2000-1 Addison Circle

Roundabout Punchlist & Closing out Documents -  
1998

## **ADDISON ROUNDABOUT SENSITIVITY ANALYSIS**

**ADDISON CIRCLE APARTMENTS  
BUILDING PERMIT PLAN REVIEW  
JANUARY 3, 1996**

↑  
1" = 20'  
SHEET W02

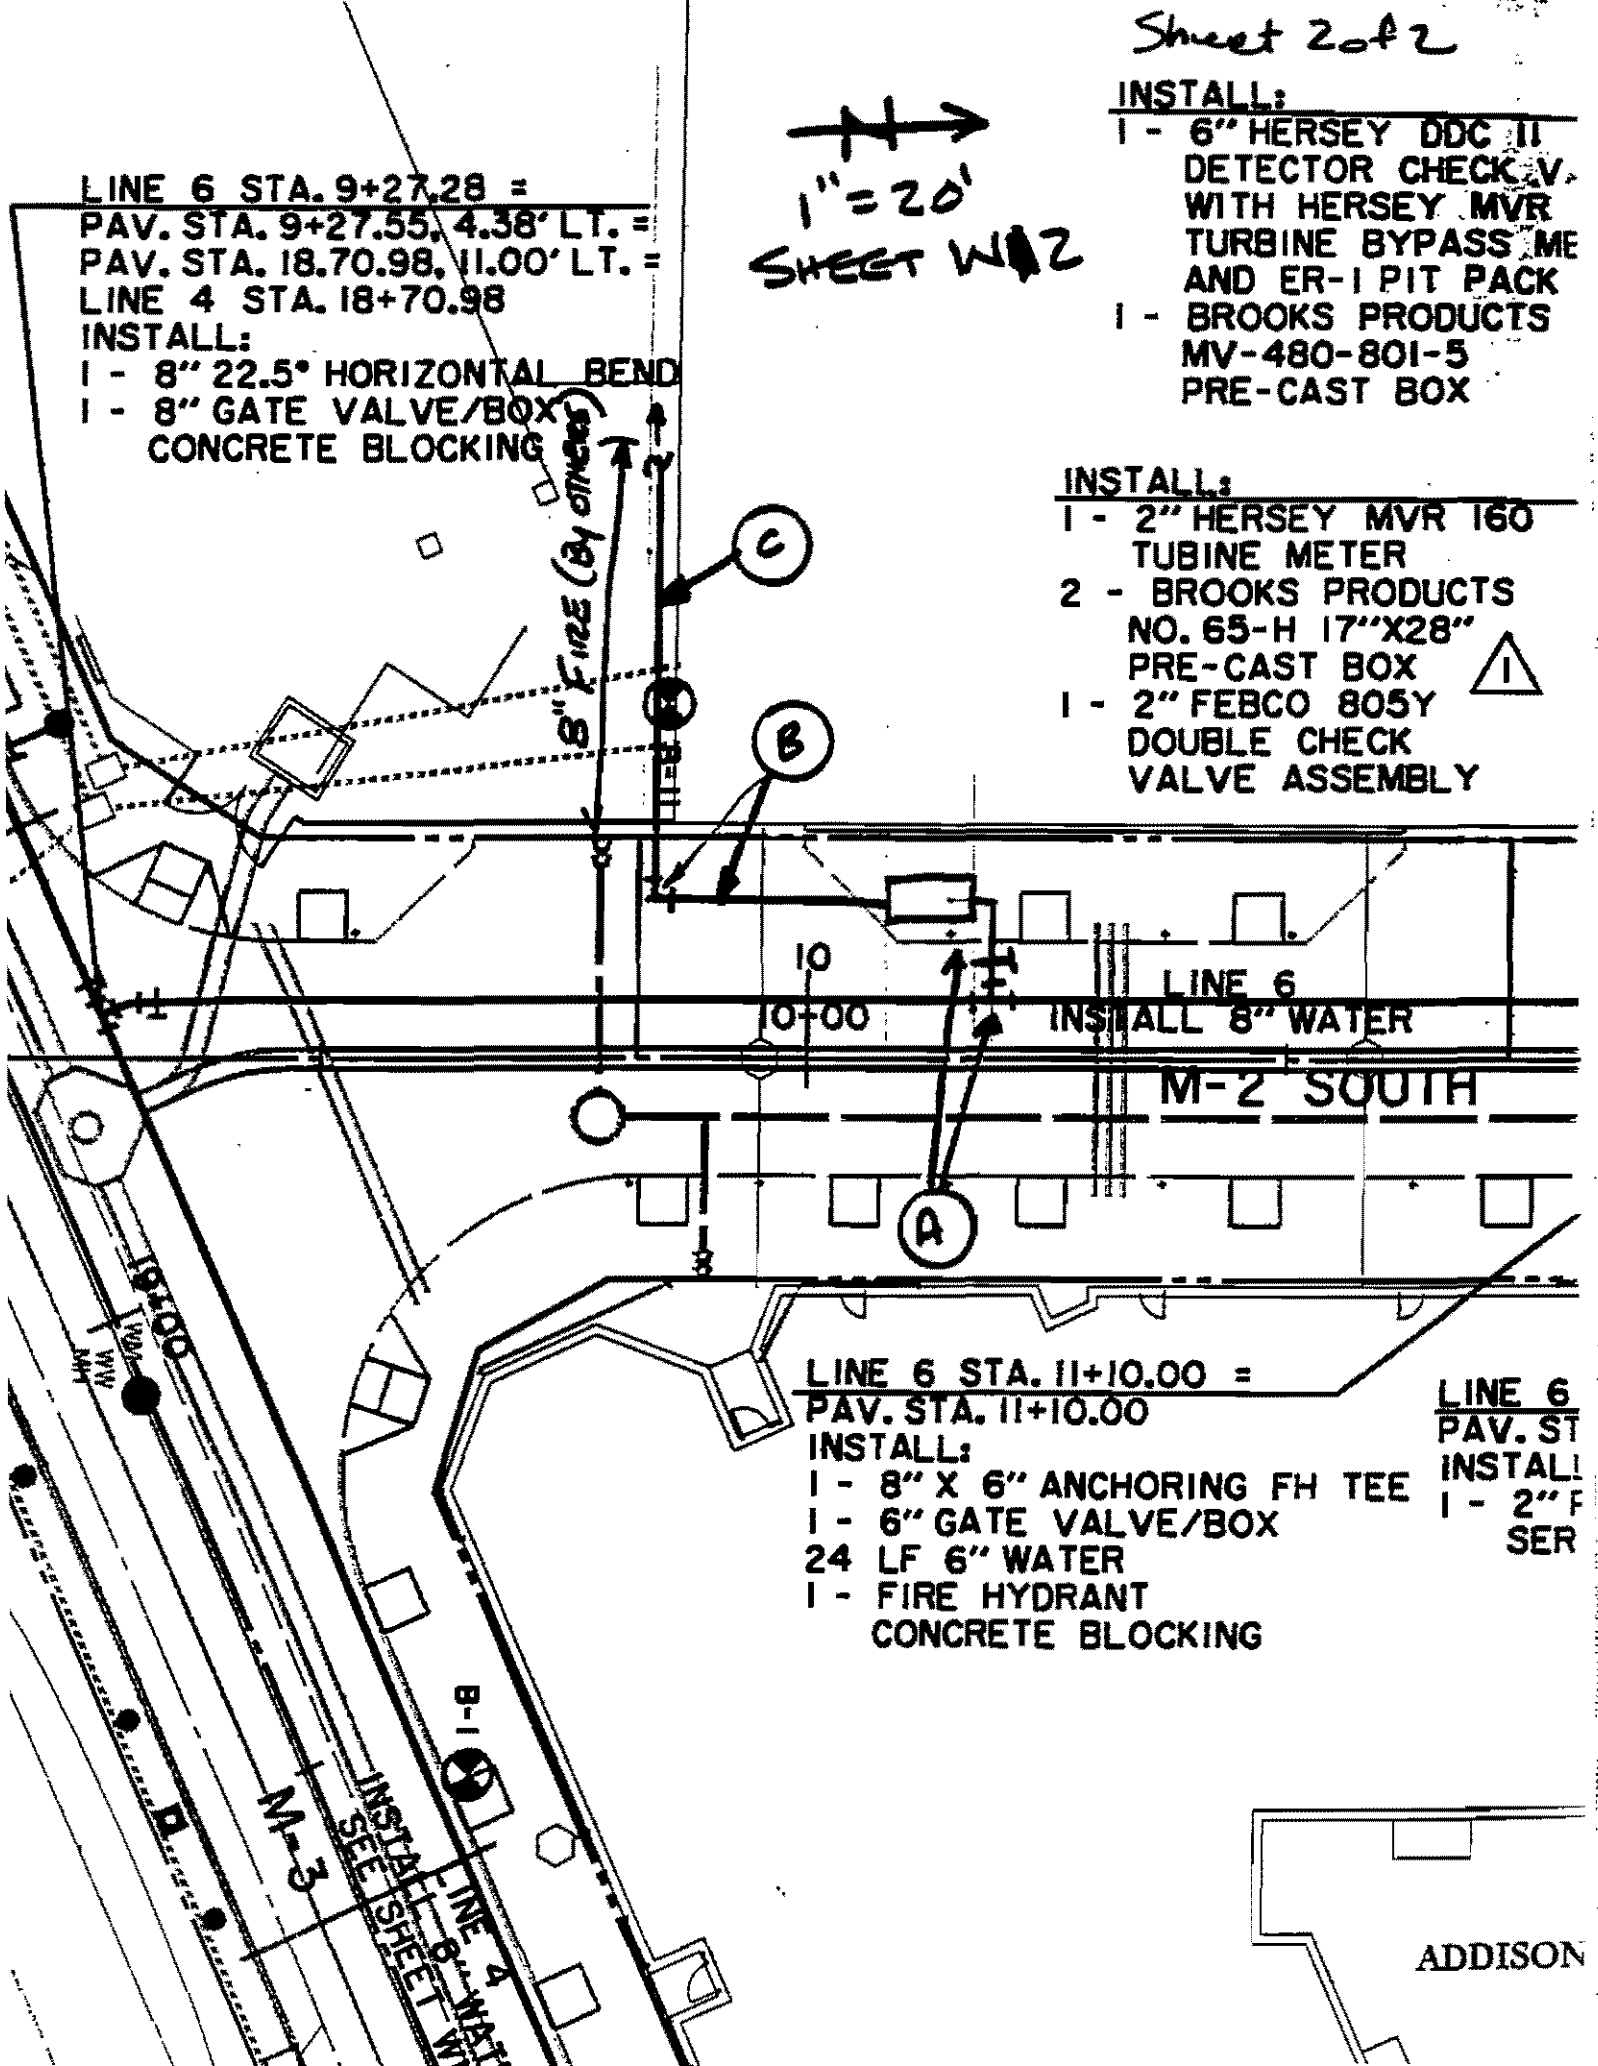
\* Keep pre-cast Box clear of driveway.
